PROJECT NAME	2123 RTE. 500 W. - EMBRUN, ON - CAMBRIDGE PUBLIC SCHOOL ADDITION - ARCHITECTURAL SERVICES - UCDSB RFQ #25-036
PROJECT NO.	GWAL 2025-385
DATE	APRIL 24, 2026
ADDENDUM NO.	E1

The following additions, deletions & revisions form part of the drawings and specifications for the above-referenced project:

scale AS SHOWN	drawn by K.A
date 2025	checked by D.V./ D.A
project number 2025-385	drawing number E003

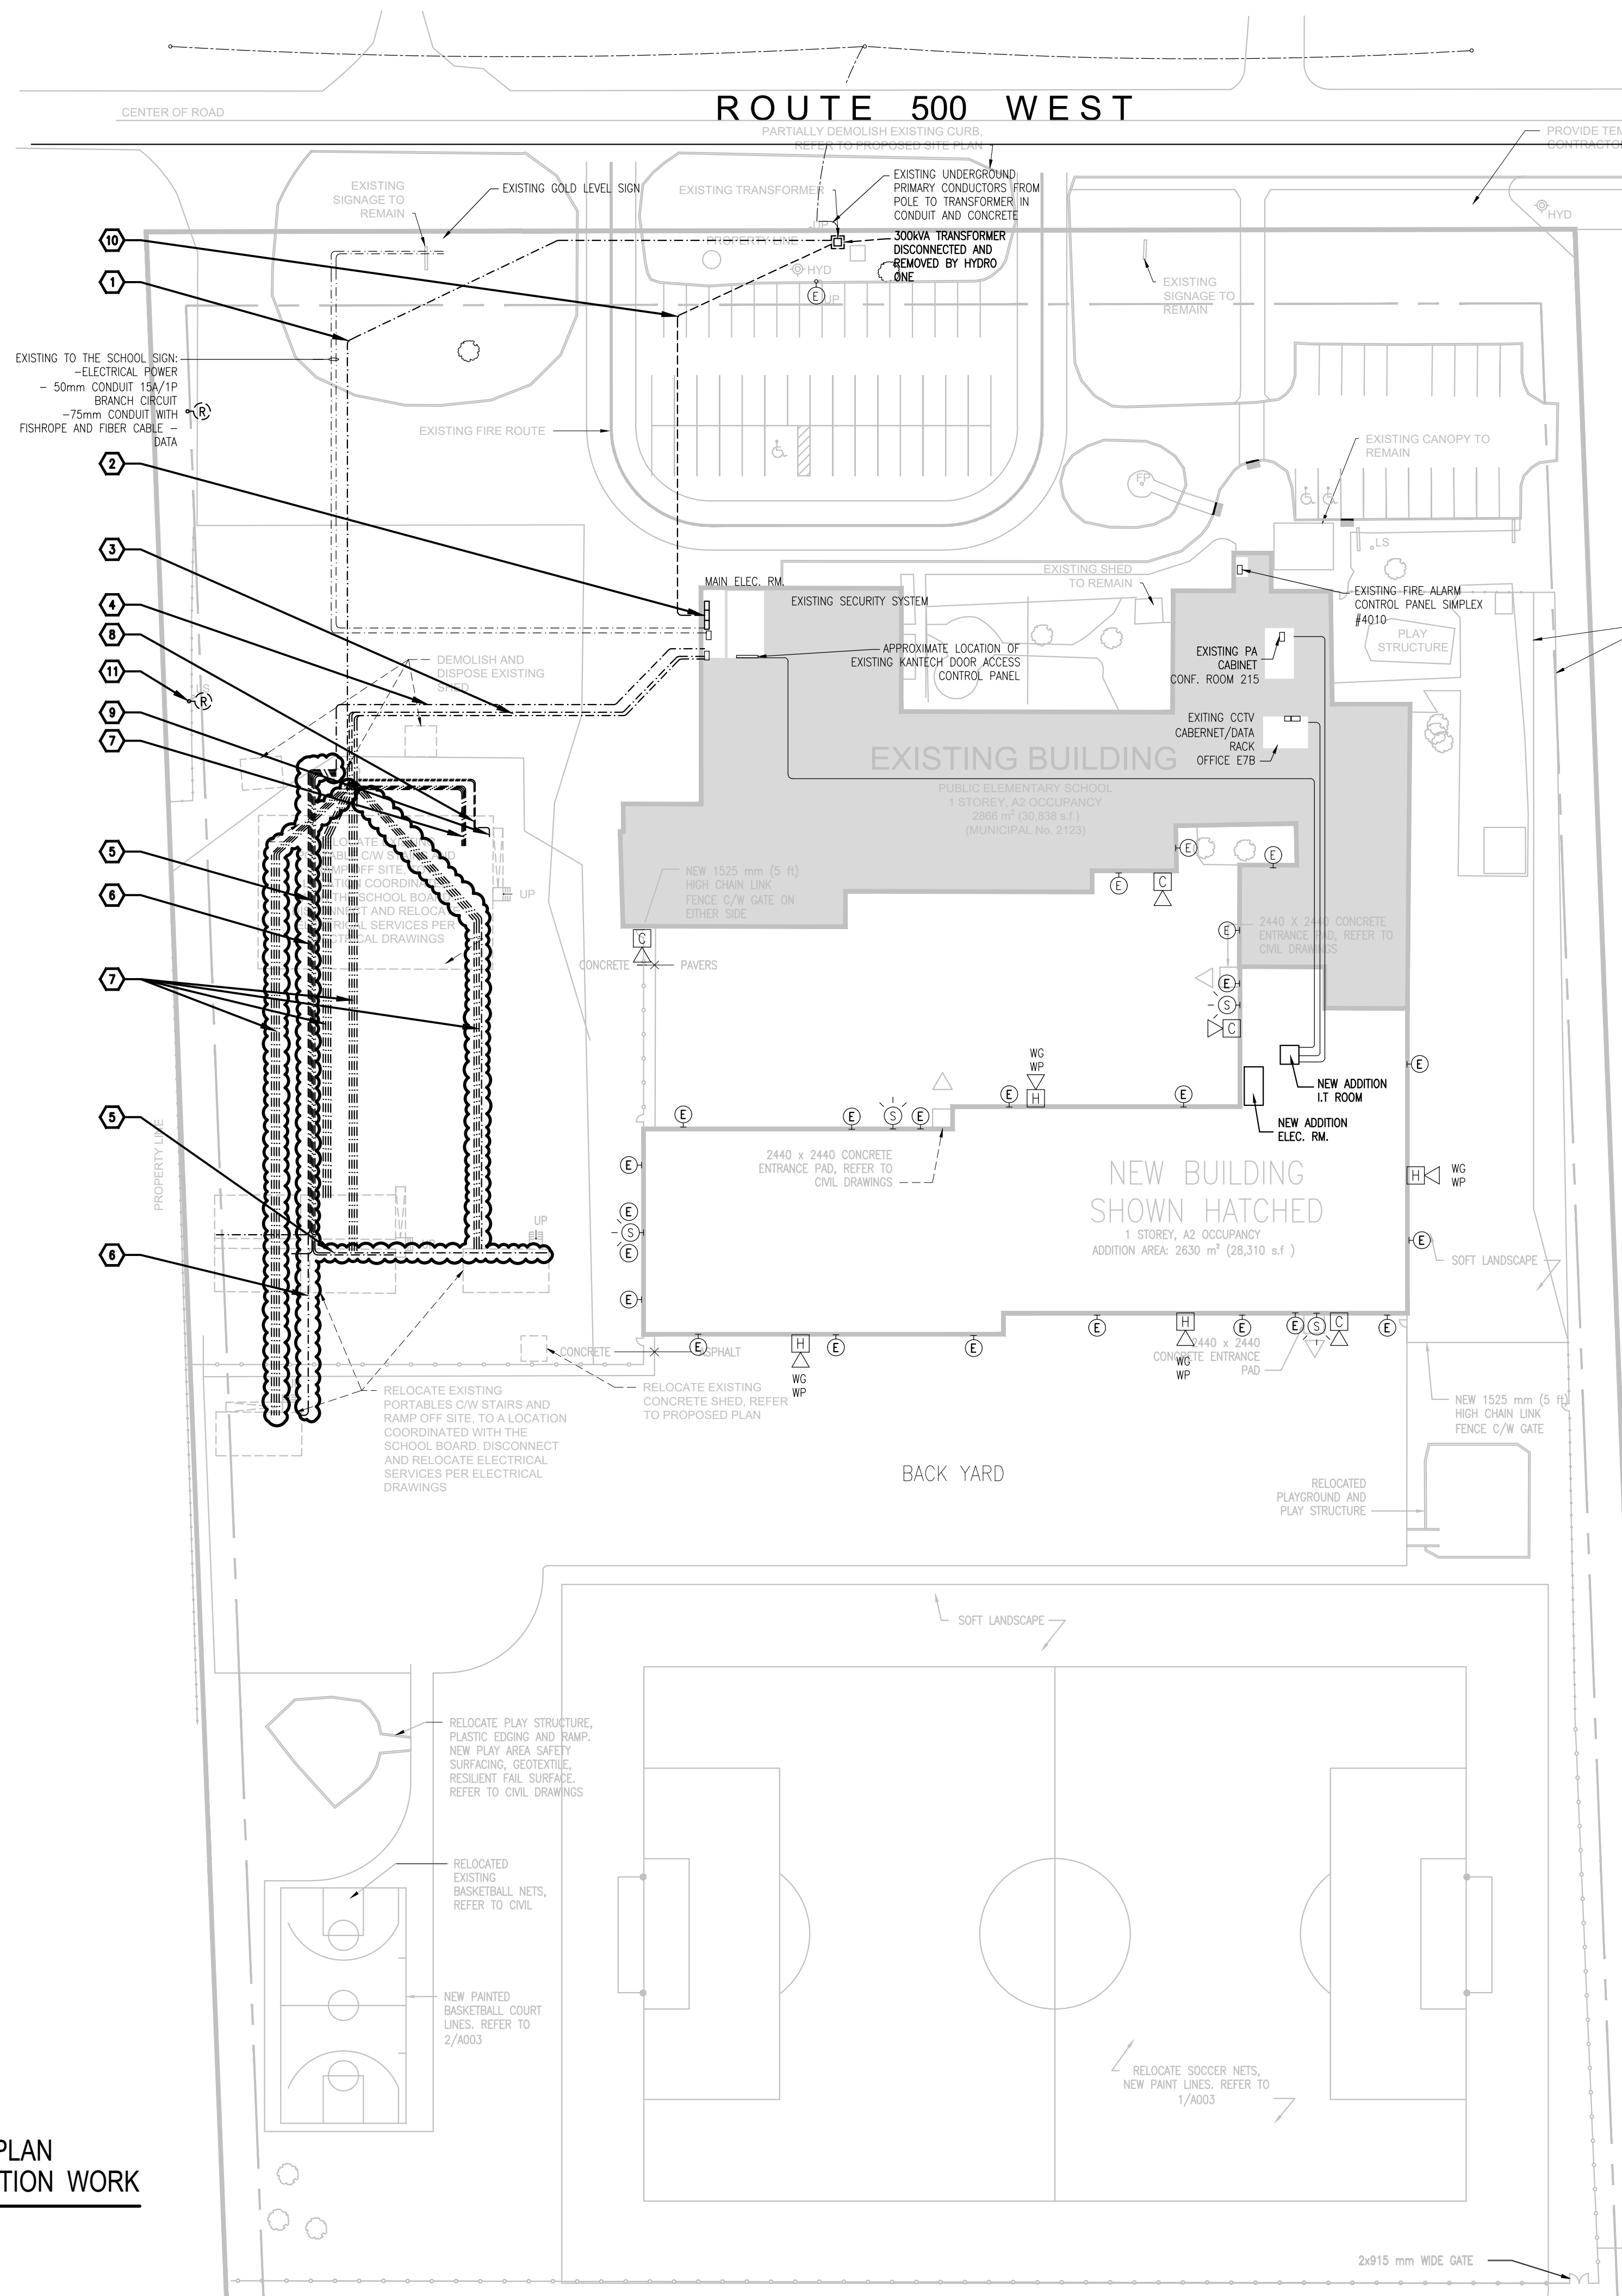
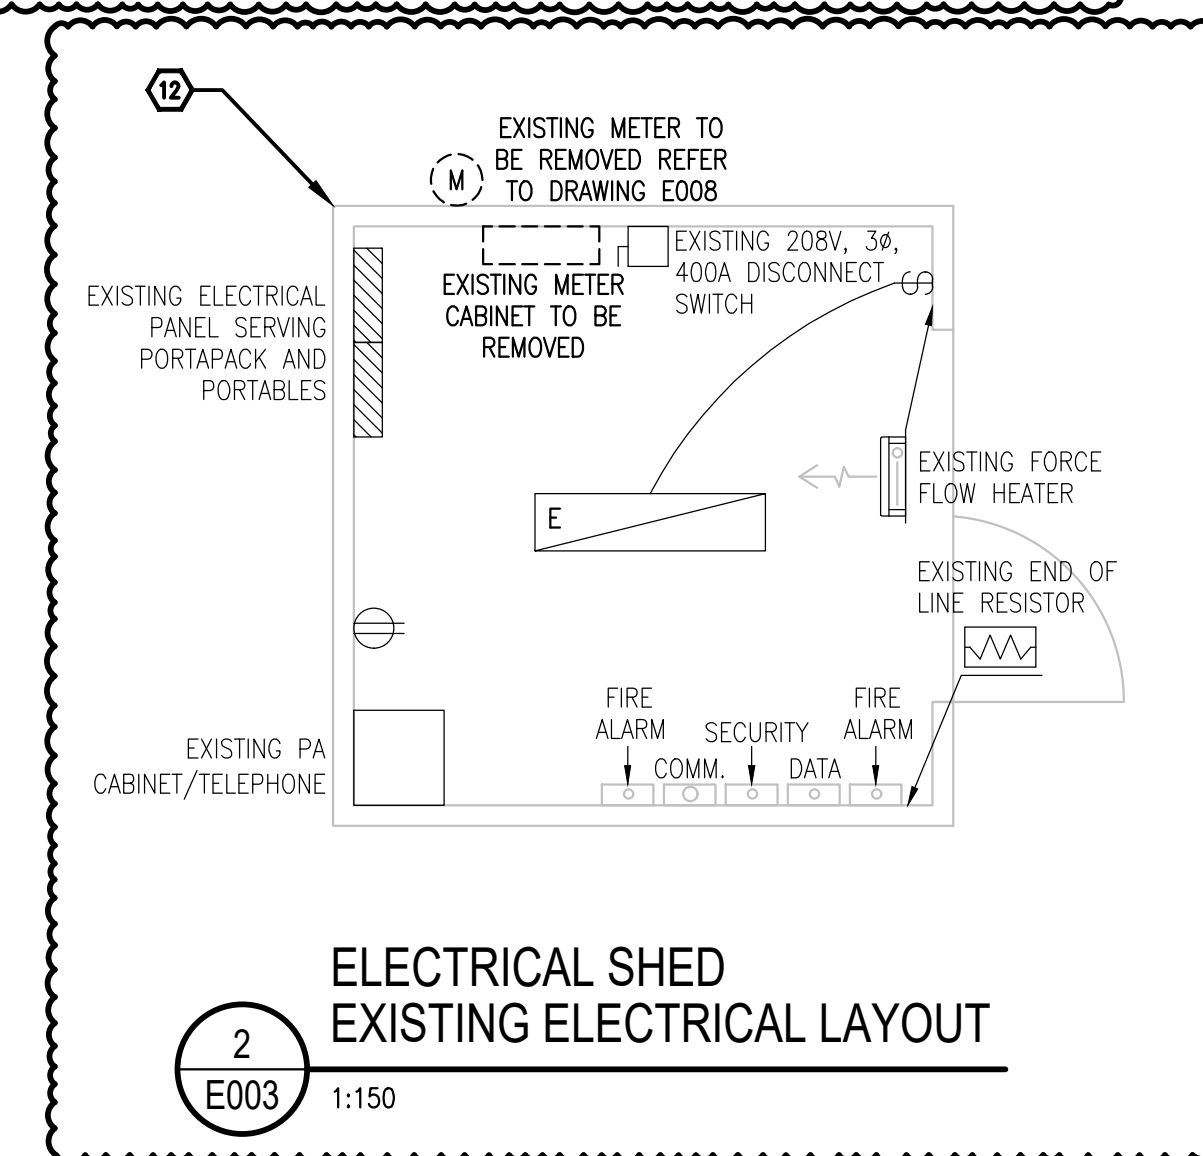
- .1 Additional demolition scope for classroom portables and associated underground services.

scale AS SHOWN	drawn by K.A
date 2025	checked by D.V/ D.A
project number 2025-385	drawing number E008

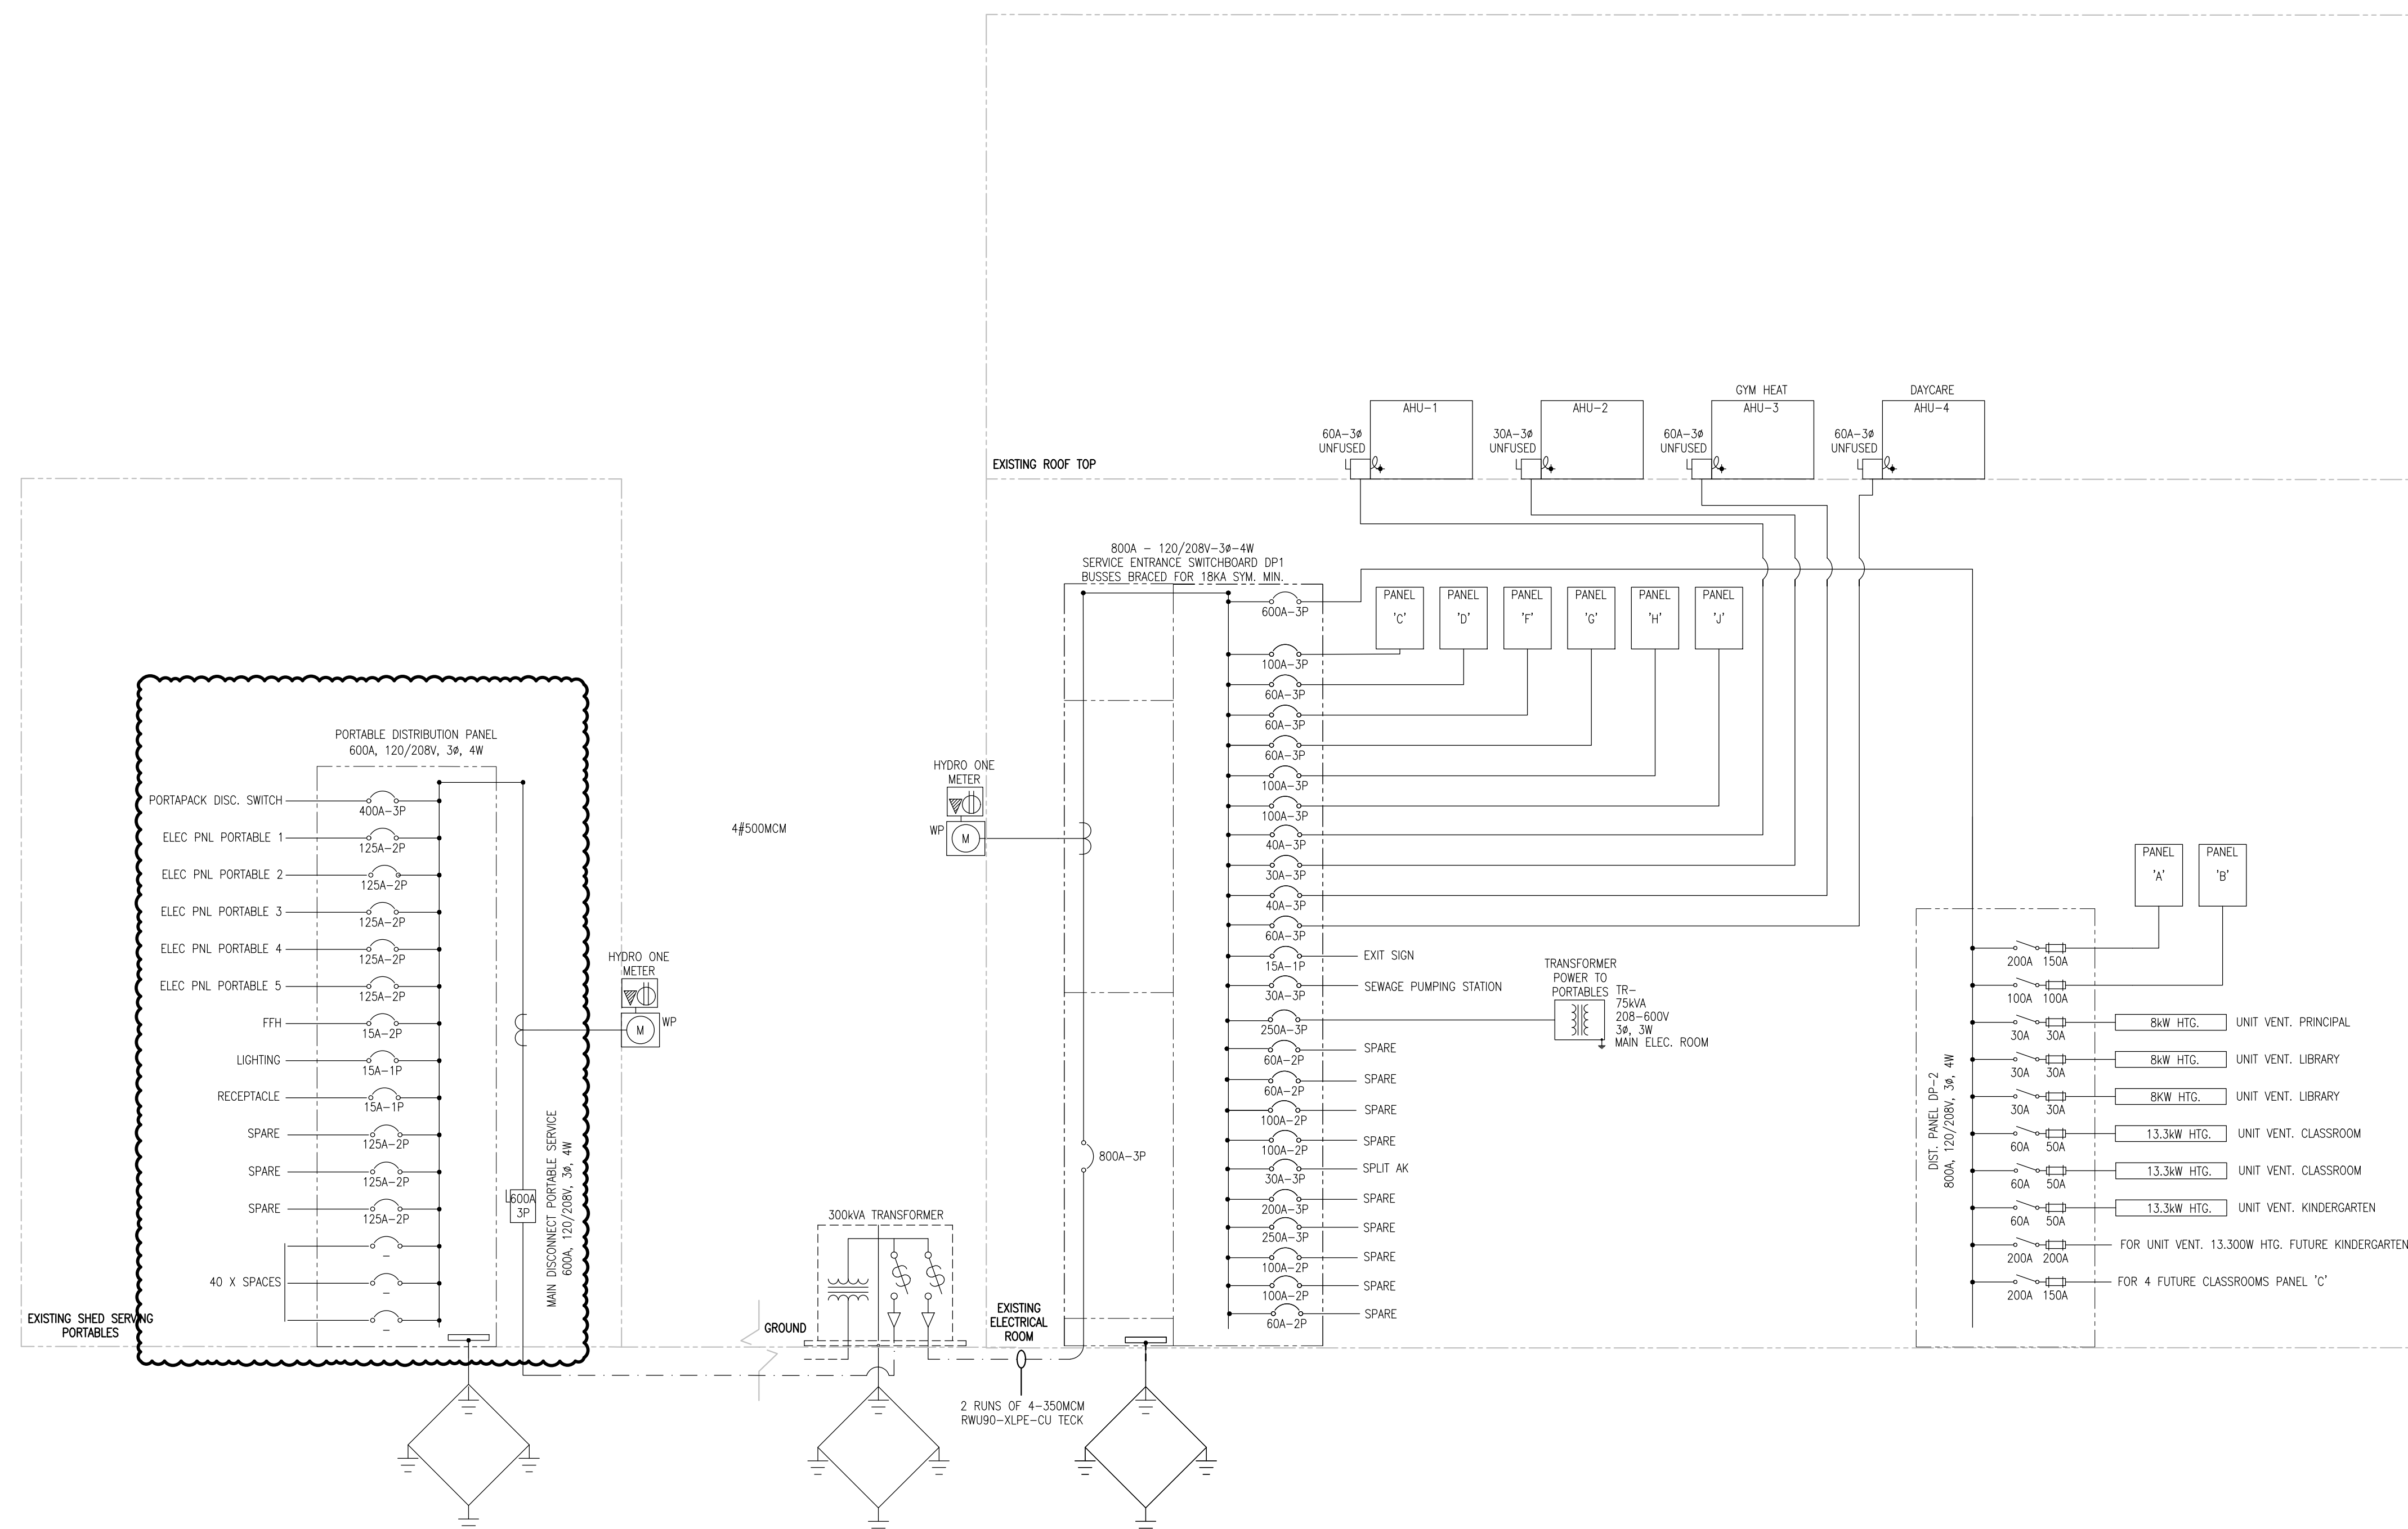
- .1 Updates to existing, demolition, and new single-line diagrams for classroom portable infrastructure.
